MAJOR PROJECT ASSESSMENT: Invincible Coal Project

Director-General's
Environmental Assessment Report
Section 75I of the
Environmental Planning and Assessment Act 1979

December 2008

Figure 4: Nearest residential receivers and representative noise assessment locations

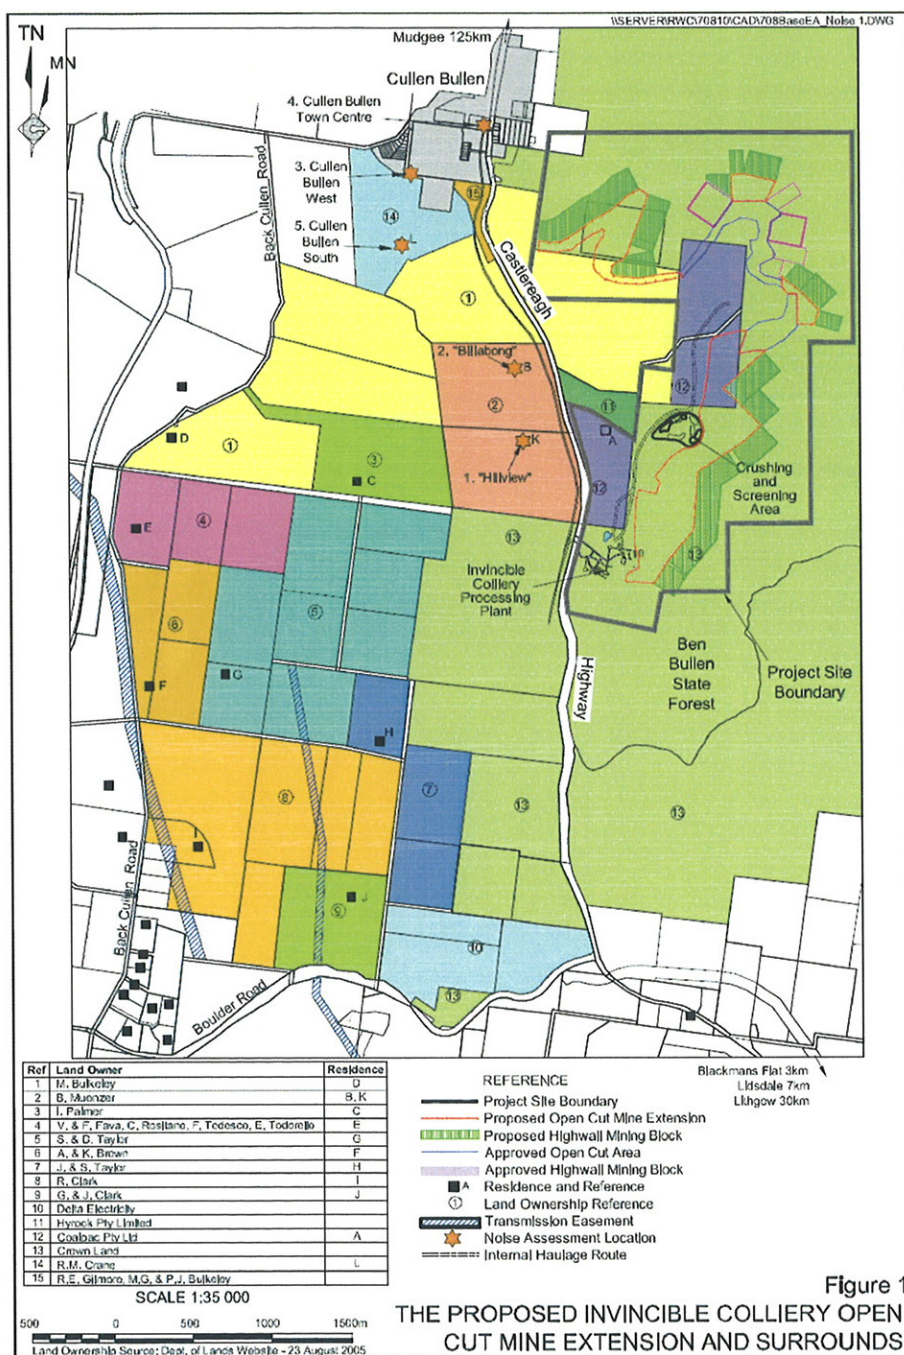
While the total noise output of the mine would increase, the distribution of noise sources throughout the site would also change, particularly with the introduction of mining in the 'West Pit'. This would see the nearest mining activities advance from around 1700 m to within 900 m of residences in the south of Cullen Bullen. Although the majority of residences in Cullen Bullen would receive significant natural noise mitigation from the intervening hill which separates them from the West Pit, residences in the south and west of Cullen Bullen are less shielded by this feature and would potentially experience increased noise impacts, most notably when prevailing winds are from the east and south. Noise modelling for the assessment used representative locations for these residences, shown in Figure 4.

These results indicate the increased likelihood of noise exceedances for residences located in Cullen Bullen South and Cullen Bullen West. Subjecting these results to a finer analysis, the following impacts are predicted at individual residences for *evening* operations during certain stages of the project:

- minor exceedances (1-2dB) at 13 residences.
- moderate exceedances (3-5dB) at 8 residences.
- significant exceedances (>5dB) at 15 residences.

All 15 significant evening exceedances (ranging from 6-10dB above the criterion) are predicted to occur only when winds are blowing from the eastern or southern quadrant ($\pm 45^\circ$). The noise assessment provided data to indicate that these exceedances would occur during Year 3 for 14 of the 15 residences and during Years 5/6 for the remaining residence. However, the Department notes that the noise assessment did not model operations or noise emissions for Years 2 and 4. Based on the proposed mining plans contained in the EA, the Department believes there is a reasonable probability that further significant exceedances would occur at the same residences during these years.

The Department and DECC share reservations concerning these proposed controls. Firstly, Coalpac position is based on a de facto acceptance of exceedances which do not meet the threshold of being "significant" (ie 5dB(A)). The Department considers all exceedances of impact assessment criteria to be a serious matter even over a short period of time and cannot agree to a practice that would effectively accommodate "less significant" exceedances within day-to-day operational management of a mine. Secondly, the proposed real-time method of implementation may not be feasible, since the scale and nature of a coal mining operation creates an inherent degree of inertia to any spontaneously imposed changes. While it may be possible to communicate orders for ceasing work to the relevant ground staff (plant equipment operators etc) almost immediately following the detection of adverse weather conditions, the actual implementation of these controls on the ground may be impractical or

unachievable in a short time frame and unreasonably delay relief for those impacted. Furthermore, as exceedances of up to 10dB are predicted at some residences, any interrogation of the real-time noise monitoring network is likely to retard the process of implementing operating restrictions and consequently prolong impacts at the affected residences.

For these reasons, the Department has included conditions of approval which would restrict the majority of proposed mining operations to the daytime period, in order to eliminate the significant exceedances predicted during the more-sensitive evening period. Specifically, these restrictions would prohibit evening mining works in all but the North Pit (as described in the EA). This principally comprises the two small open cut extensions shown on the cover photograph of this report. Further auger mining in the North Pit would be the only mining permitted during the evening period. However, Coalpac would be permitted to continue to undertake coal processing and transportation activities and all other mining-related activities permitted under its existing approval. For the remaining open cut pits described in the EA (West Pit, Central (Renown) Pit and South Pit) open-cut and auger mining operations would only be permitted during daytime hours.

The Department is confident that these restrictions would prevent the predicted significant noise impacts for these 15 residences. However it has provided Coalpac with the opportunity to have these restrictions lifted, in the event that it can reach written agreements with all residences to accept the predicted noise levels.

The Department notes that in spite of these restrictions, there would still be a residual potential for moderate (3-5dB) exceedances of the evening noise criterion to occur at these residences and, for one of these residences, further notes that moderate exceedances of the daytime noise criteria are predicted in the later years of the project. Consequently, the Department has included conditions that would require Coalpac to install architectural noise treatment (such as double glazing, insulation and/or air-conditioning) at any residence where noise monitoring shows moderate exceedances of either the day or night-time criteria.

This monitoring would form part of a broader requirement to prepare and implement a Noise Monitoring Plan, involving a significant expansion of Coalpac's existing noise monitoring network to include additional monitoring locations in Cullen Bullen South and Cullen Bullen West as well as contemporary noise monitoring equipment with the capacity to accurately determine noise levels at individual residences.

Figure 5: Key vegetation elements on project site

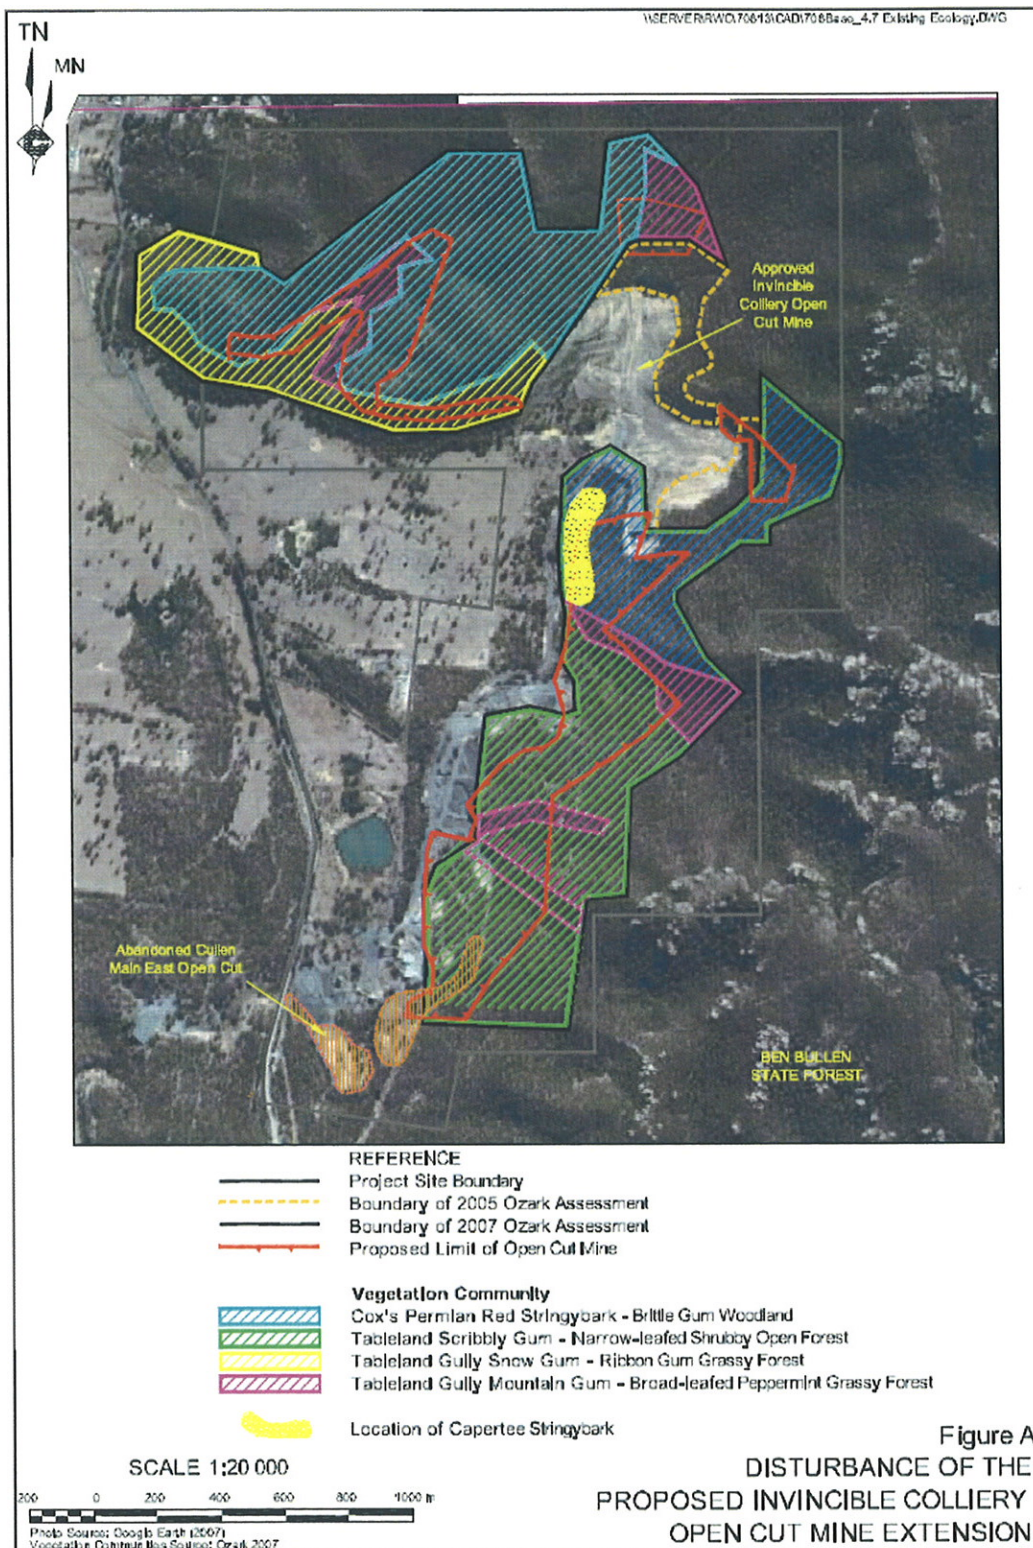
Also identified in the assessment was the presence of one threatened flora species, Capertee Stringybark (*Eucalyptus cannonii*), occurring over approximately 1 ha of the project site (comprising approximately 50 individuals). This community is shown, together with the four vegetation communities, in Figure 5 below.

With regards to Capertee Stringybark, the assessment noted that there were at least 20,000 individuals recorded within 14 existing conservation reserves across the State. However it also noted that the 100 individuals recorded within the study area (half of which were proposed to be cleared, with the remainder of the population immediately adjacent) constituted a 'local population' that would potentially be placed at risk of extinction.

- failure to maintain or improve biodiversity values (DECC considers this is essentially due to the 'high level of risk' associated with successfully implementing the strategy); and
- lack of certainty surrounding the number of Capertee Stringybark trees that would be cleared/retained.

Coalpac has since committed to retaining and preserving all Capertee Stringybark trees on the site by eliminating mining activities from the 1 ha area where they occur and reducing the overall disturbance
